**ADDENDUM TO PREFERRED PROJECT REPORT (DECEMBER 2009)  
MAJOR PROJECT APPLICATION NO. 08\_0034**

**PROPOSED SUBDIVISION AT LOTS 2 AND 3 DP 244652  
URLIUP ROAD BILAMBIL  
(TWEED LOCAL GOVERNMENT AREA)**

**MARCH 2010**

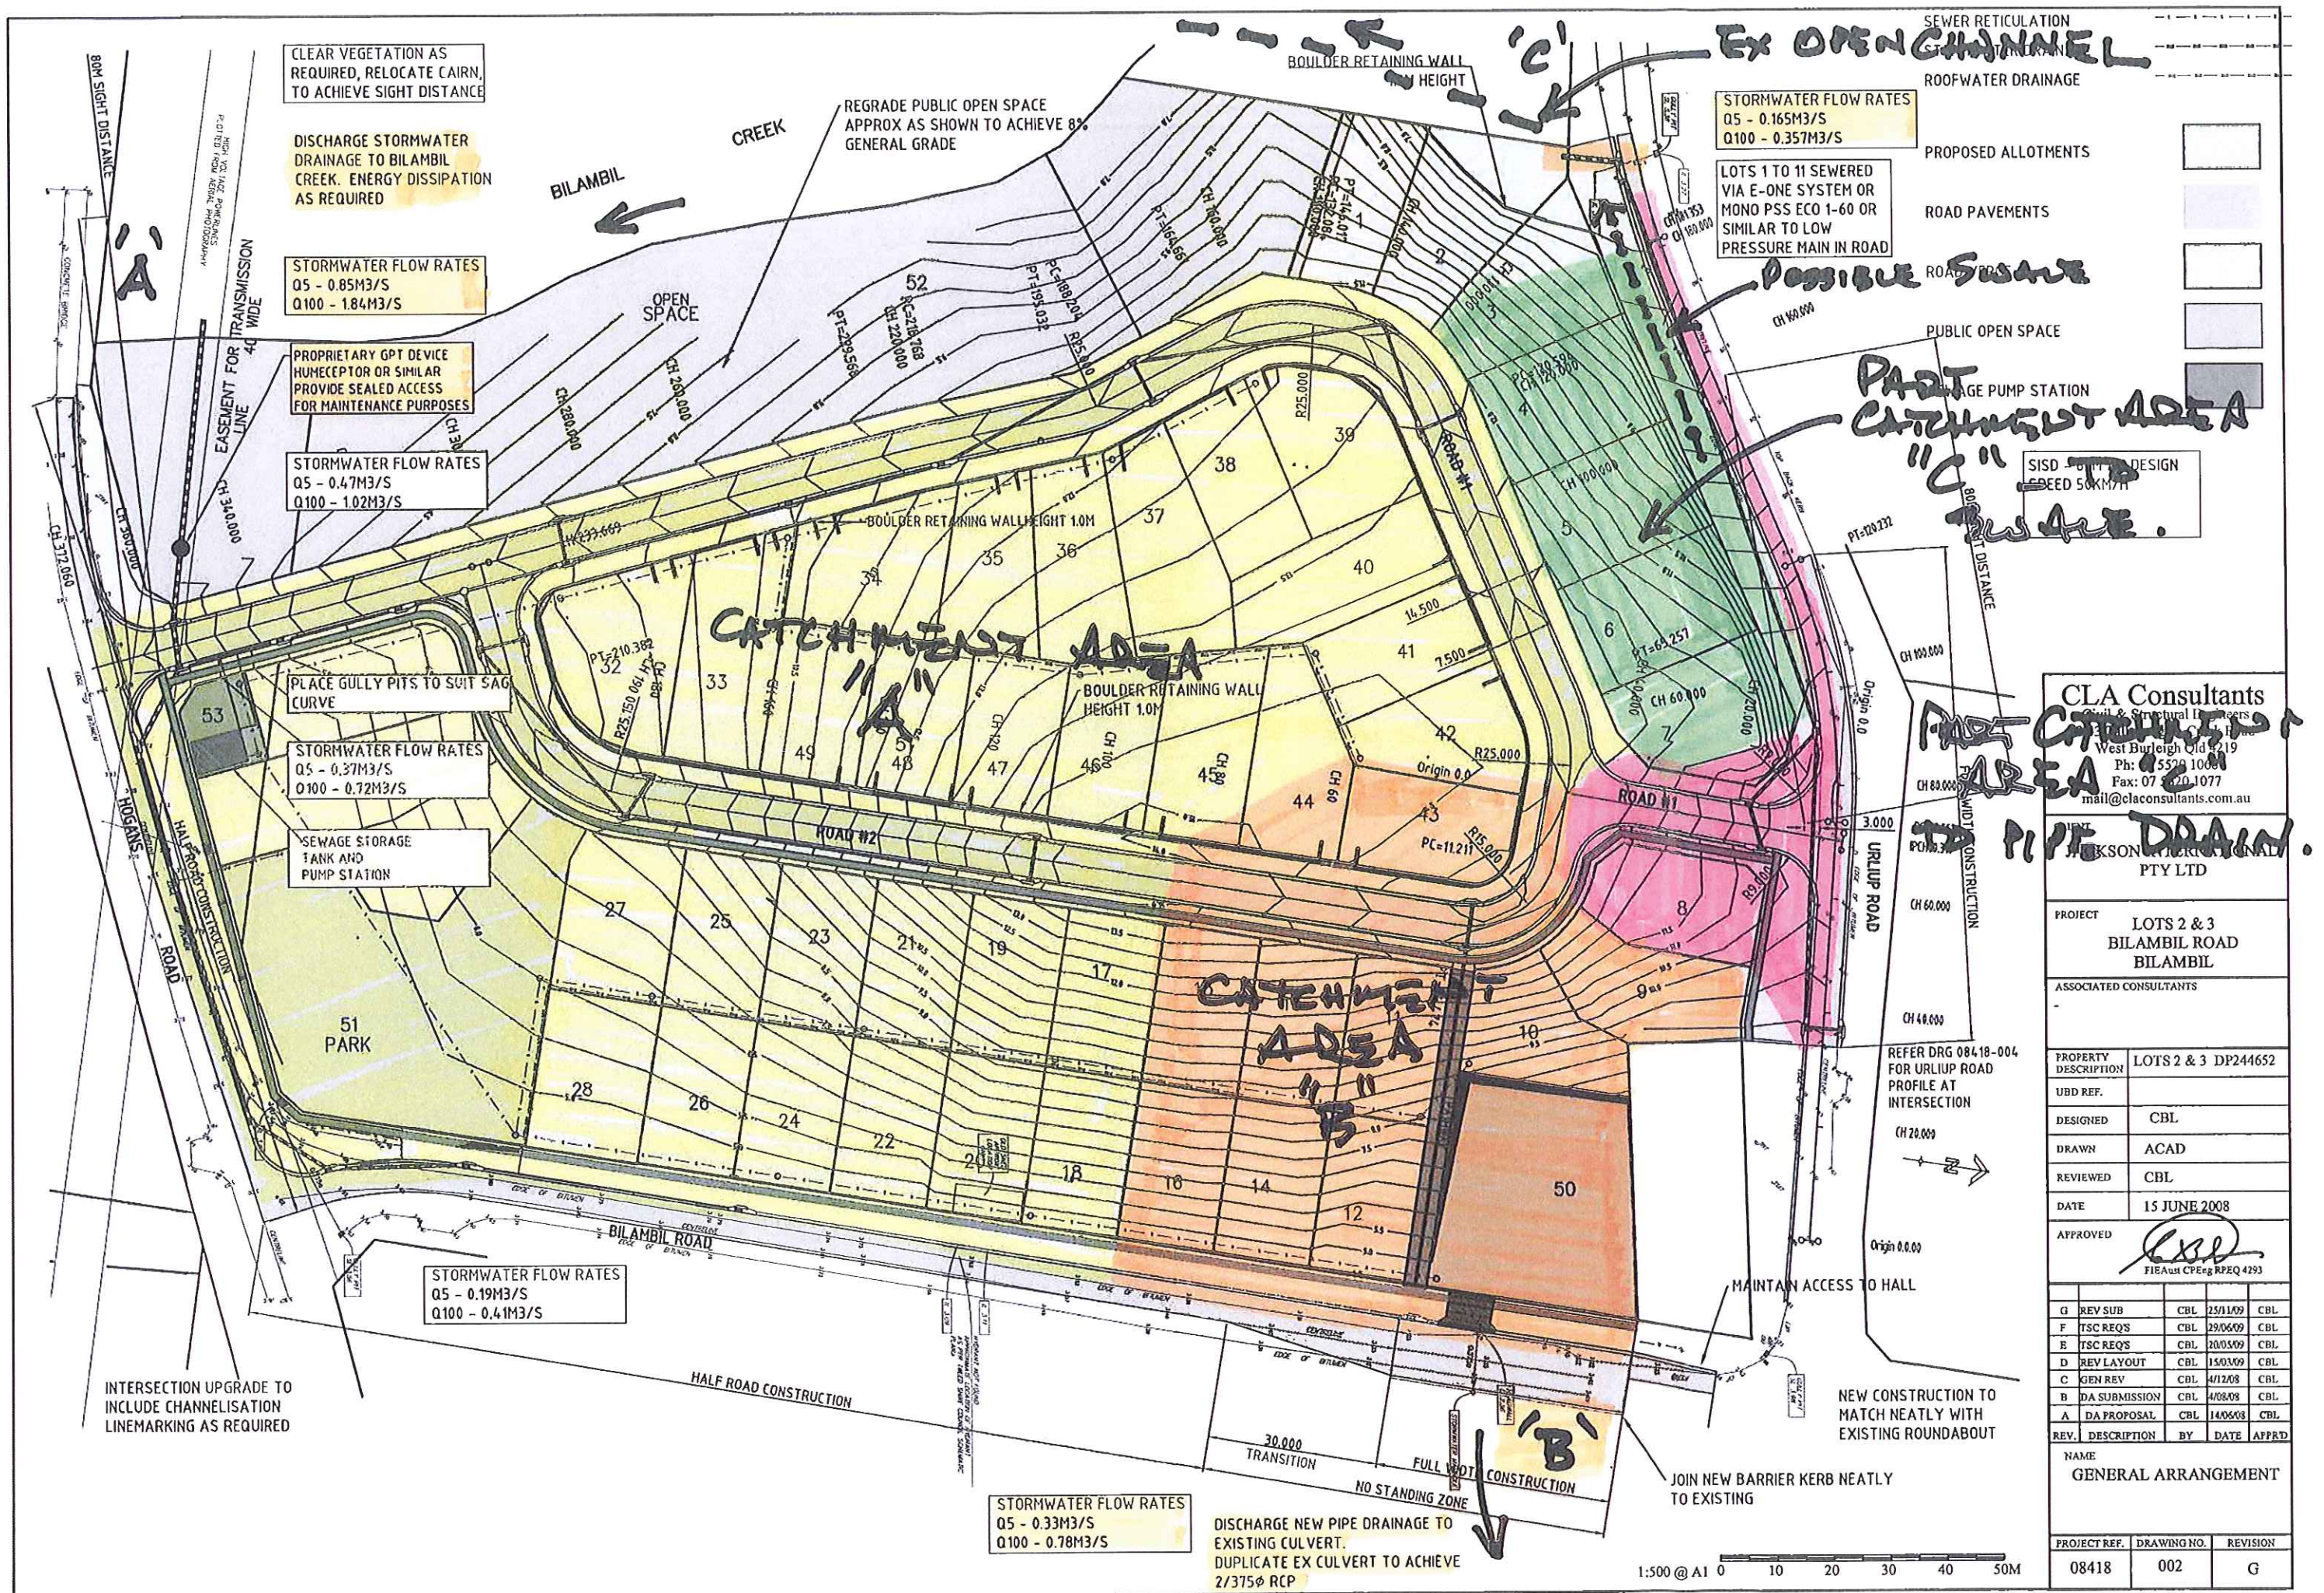
- 1 - In sizing the required culverts under Bilambil Road for catchment "B", the applicant will need to consider all associated external catchments. This would include the external catchment that I have anticipated in blue on the attached "Marked up" drawing. Again, this can be addressed at CC Stage.

- 2 - Council require the frontage of the development to Uriup Road to be upgraded to a standard urban profile (as should be enforced in the Imposed conditions). Hence the road verge will grade at 2.5% to the kerb and will not accommodate a grass swale (as suggested behind Los 3-5). However the opportunity to incorporate a swale could be considered at CC stage.

- 3 - Council will only support the utilisation of the existing open channel to treat runoff from Uriup Road if it can be shown that it provides the appropriate treatment in accordance with the requirements stipulated in Council's Design Specification D7 - Stormwater Quality. This can be assessed using MUSIC modelling (or the like) at CC Stage. If it is determined that inadequate channel length or grade is available, then the development will need to look at alternative treatments and may resort back to installing an end of line, oil, grit arrestor. Again, this can be assessed at CC stage.

- 1. The Site-Based Stormwater Management Report (Attachment 3 of the civil engineering report in Annexure G of the PPR) includes plans that do not show all treatment devices proposed. It is unclear from the plans as to how many discharge points there are (2?), and whether grass swales are proposed to filter runoff before it hits Bilambil Creek from the northern catchment of the development (due to it being a smaller catchment). Please provide a plan that clearly shows all stormwater catchments post-landforming (2 or 3 catchments?) and their ultimate discharge points. This plan should clearly indicate any other Water Sensitive Urban Design (WSUD) measures proposed across the development. The Department requires certainty that appropriate stormwater management will take place in the absence of any detailed ecological assessment of stormwater impacts, and due to a reduced Riparian Management Zone width (35m, normally 50m).*

There are three discharge point from the project, as shown on our marked up drawing attached.

The runoff from the major catchment (marked "A" on the plan) is directed to Bilambil Creek. This runoff flows through the proposed water quality improvement device in accordance with Council's recommendation/requirements.

The outlet ("B" on the plan) discharges to an existing overland flow path on the Eastern side of Bilambil Road. There are no water quality improvement devices proposed at this point. It will be understood that Council's requirements in respect of the required upgrading works in Bilambil Road, ie in accordance with the specified cross section included in the drawings, preclude the construction of swales etc. Likewise, the construction of swales within the development site per se will not satisfy the relevant provisions of the LEP, on the basis that the longitudinal grades do not fall within the specified tolerances.

The outlet "C" (on the attached plan) drains to an existing open channel that currently serves as an outlet from the existing 1.5m Dia culvert under Urliup Road.

Council has advised that it does not require the installation of a GPT at the outlet of this catchment, but that it may be acceptable to construct swales in association with the proposed section in Urliup Road. Review of the existing situation highlights the difficulty with this approach.

The longitudinal section of Urliup Road (refer drawing 08418-005 Rev E) shows the longitudinal grade at greater than 7% for a significant length. The discharge of the required pipe drainage to a swale in the footpath is problematic, however it would appear to be possible to provide a vegetated swale in the footpath to treat the runoff from Lots 3, 4, 5, 6 and 7. Thus, whilst it may not be possible to treat all of the runoff from Catchment "C", it is possible to treat a significant proportion.

The attached sketch summarises the three catchments and indicates the location of water quality improvement devices.
